Response to Council Report

CHURCH & COMMUNITY & BOARDING HOUSE DEVELOPMENT

28 FISHER RD & 9 FRANCIS ST, DEE WHY, NSW

COUNCIL ASSESSMENT REPORT	
Panel Reference	PPSSNH-155
DA Number	DA20201167
LGA	Northern Beaches Council
Proposed Development	Demolition works and construction of a mixed use development to accommodate a cafe, church, conference centre, boarding house and two level basement car park
Street Address	Part Lot 26 DP 7413, 9 Francis Street and 28 Fisher Road, Dee Why
Applicant/Owner	Baptist Churches of NSW Property Trust (Owner) The George Group Pty Ltd (Applicant)
Date of DA lodgement	22 September 2020
Number of Submissions	38 submissions which includes: <ul style="list-style-type: none"> 16 submissions in support, 22 submissions in opposition
Recommendation	Refusal
Regional Development Criteria (Schedule 7 of the SEPP (State and Regional Development) 2011)	Development with a Capital Investment Value (CIV) of more than \$5 million for affordable housing (which includes a Boarding House)
List of all relevant s4.15(1)(a) matters	<ul style="list-style-type: none"> Environmental Planning and Assessment Act 1979 Environmental Planning and Assessment Regulation 2000 State En

Figure 6: Zoning Map (part R3/part B4)

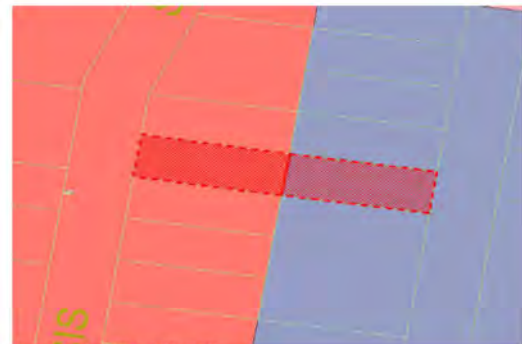
In addition to being subject to a split zoning, the site has a split maximum building height control applying, comprising of 11.0m on the R3 zoned land and 16.0m on the B4 Mixed Use zoned land.

Noted

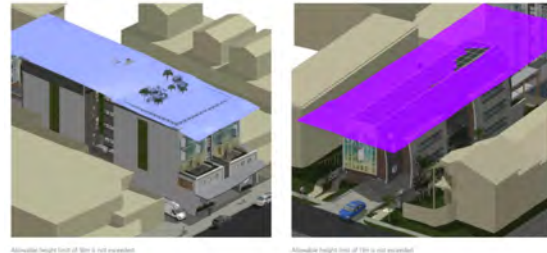
Standard	Permitted	Proposed	Variation
4.3 – Height of Buildings	The maximum building height of the B4 zone is 16m (13+3) as per Dee Why Town Centre Masterplan 11m within R3 Medium Density Zone	The proposed development has a maximum building height of 11m on the western portion and 16m on the eastern portion of the site.	N/A
4.4 – Floor Space Ratio	2.4:1 for B4 zone The SEPP (ARH) 2009 provides for an additional 0.5:1 additional FSR under Clause 29. Therefore, the proposed development has a maximum FSR control of 2.9:1.	The proposed development has a total GFA of 3,312.84m ² which equates to a FSR of 2.38:1.	N/A

Heights of 11m and 16m are adhered to
